Access Compliance Report

Public Rights-of-Way

(Curb Ramps)

Intersection ID: 10017066	Main Street: NEAL_RD	Cross Street: N/A	Location: NE
ADA ID: 1B9B0DA01134	Ramp Type: PerpDiag	Initial Pass/Fail: Fail	Overall Compliance: No
		Severity Score: 42.5

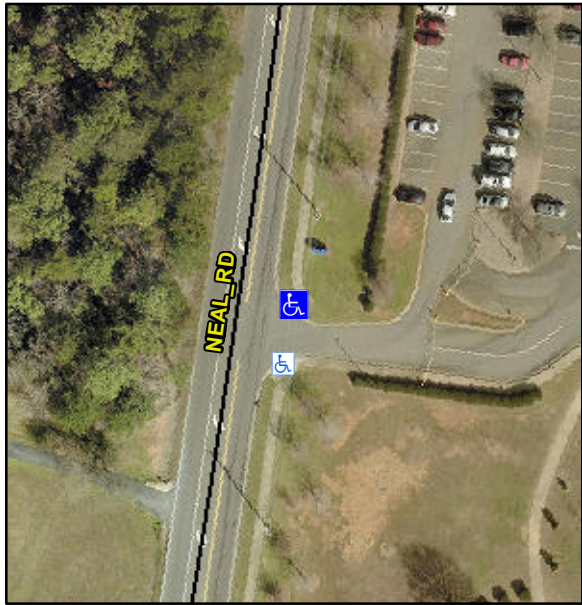
Codes/Mitigation Info/Possible Solution			Field Measurements/Component Compliance					
	Possible Solutions:		Compliance	Description	Data	Compliance	Description	Data
	Remove & Replace Curb Ramp With Two New Directional Ramps or Equivalent.		N/A	Ramp Length (in)	130.0	No	Ramp Slope (%)	9.1
			No	Ramp Width (in)	32.5	No	Ramp XSlope (%)	5.2
			N/A	Flare Type LT	N/A	N/A	Flare Type RT	N/A
			N/A	Flare Slope LT (%)	N/A	N/A	Flare Slope RT (%)	N/A
			N/A	Flare Traversable LT?	N/A	N/A	Flare Traversable RT?	N/A
			N/A	Landing Length (in)	N/A	N/A	DWS Provided?	N/A
			N/A	Landing Width (in)	N/A	N/A	DWS Contrast?	N/A
			N/A	Landing Slope (%)	N/A	N/A	DWS Length (in)	N/A
			N/A	Landing X Slope (%)	N/A	N/A	DWS Full Width?	N/A
Surveyor Notes:		N/A	N/A	Landing Curb? (Y/N)	N/A	N/A	DWS Offset (in)	N/A
			N/A	Shared Landing?	N/A			
PROW/ADA:			N/A	Gutter Ponding?	N/A	N/A	Gutter Slope (%)	N/A
Not Found, R304.5.1, R304.2.2, R304.5.3			N/A	Gutter Lip Ht (in)	N/A	N/A	Gutter X Slope (%)	N/A

N/A	Painted X Walk1?	No	N/A	Painted X Walk2?	No
				X Walk 1 Direction	To W		X Walk 2 Direction	To S
			N/A	X Walk 1 Width (in)	N/A	N/A	X Walk 2 Width (in)	N/A
				X Walk 1 Slope (%)	8.7		X Walk 2 Slope (%)	6.9
				X Walk 1 X Slope (%)	2.7		X Walk 2 X Slope (%)	7.1
			N/A	Ramp inside XWalk1?	N/A	N/A	Ramp inside XWalk2?	N/A
				Road Slope (%)	5.1	N/A	Clear Space?	N/A
				Road X Slope (%)	9.0	N/A	Clear Space to XWalk (in)	N/A
			N/A	Any Obstructions?	N/A	N/A	Storm Grate/Utility Hazard?	N/A
				Obstruction Type			Storm Grate/Utility Type	
					N/A			N/A
						Yes	Surface Condition? (G/P)	Good
Total Cost:		\$ 3200.00						
Street 1 Name		NEAL RD						
Stop Condition-Street 2		None						
Street 2 Name		ENTRANCE						
Stop Condition-Street 1		None
